Access Compliance Report Public Rights-of-Way (Curb Ramps)

Main Street: VAGAR_ST Cross Street: PLATAL_ST Location: SW

ADA ID: RPRK211119141303 Ramp Type: Type 4 - Parallel Initial Pass/Fail: Fail Overall Compliance: No Severity Score: 2

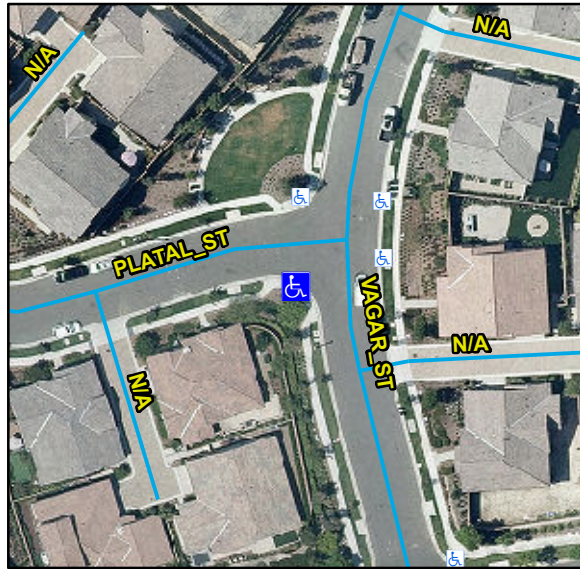
R304.2.2, R304.5.3, STD 1115

Compliance	Description	Data	Compliance	Description	Data
N/A	Ramp Length LT (in)	122	N/A	Ramp Length RT (in)	115
Yes	Ramp Width LT (in)	49	Yes	Ramp Width RT (in)	49
Yes	Ramp Run Slope LT (%)	1.4	Yes	Ramp Run Slope RT (%)	5.5
No	Ramp Cross Slope LT (%)	2.2	Yes	Ramp Cross Slope RT (%)	1.9
N/A	Landing Present	N/A	N/A	DWS Provided	N/A
N/A	Landing Length (in)	N/A	N/A	DWS Contrast	N/A
N/A	Landing Width (in)	N/A	N/A	DWS Length (in)	N/A
N/A	Landing Run Slope (%)	N/A	N/A	DWS Full Width	N/A
N/A	Landing Cross Slope (%)	N/A		DWS Offset Type	N/A
N/A	Landing Movement Obstructed?	N/A	N/A	DWS Offset Left (in)	N/A
	Landing Movement Type	N/A	N/A	DWS Offset Right (in)	N/A
N/A	Landing Shared	N/A			
N/A	Clear Space	Yes			
N/A	Clear Space To Crosswalk (in)	N/A			
N/A	Marked Crosswalk 1	No	N/A	Marked Crosswalk 2	No
	Crossing 1 Direction	E		Crossing 2 Direction	N
	Marked Crosswalk 1 Width (in)	N/A		Marked Crosswalk 2 Width (in)	N/A

Remove & Replace Curb Ramp With Two New Directional Ramps or Equivalent.
